RE: PLUS review – 2008-07-02; Deerbrook Subdivision

According to the information received, you are seeking site plan review for 135 residential units on 57.63 acres.

Please note that Kercher Engineering, Inc. has been contracted by Alpaco V, LLC to take-over the planning process for the proposed development. Comments to the State Planners comments are contained within this document and are identified in bold red to make them easier to distinguish. Kercher Engineering's contact information is as follows:

PRELIMINARY PLAN (Not to Be Recorded)

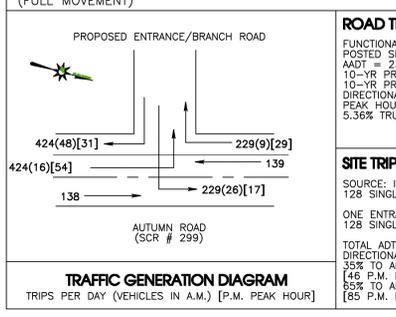
1. Remove or relocate lots and infrastructure (stormwater ponds included) that are within 100 feet of wetlands. Based on the site plan provided, there are numerous lots, several stormwater ponds, and portions of streets which are too close to existing wetlands. Also, what measures will be taken to ensure that future homeowners do not continue to clear this buffer zone even more for pools, sheds, kennels, landscaping, etc.?

- Baseball/Softball Fields. These activities should be considered to provide recreation/open space for the community.
2. DNREC supports the incorporation of a play area within the Deerbrook Subdivision but recommend repositioning it to a more centralized location. It is recommended that lots 89-92 be replaced with a play area. By moving the play area to this location, you will:

Please note that the revised subdivision design provides for 50' forested buffers from any delineated wetland area, as is required by Sussex County. Providing said buffers will create a separation between the delineated wetlands and individual lots within the proposed subdivision.

Please note that the playground area has been removed from the development plan. This was done to remove the playground from an isolated area and to allow the homeowners' association an opportunity to establish a recreation area that would best fit the community. The applicant does not object to having a recreation area but would like to leave the decision as to what would be placed in that area in the hands of the association, as they will ultimately be responsible for maintaining any structure or feature placed therein.
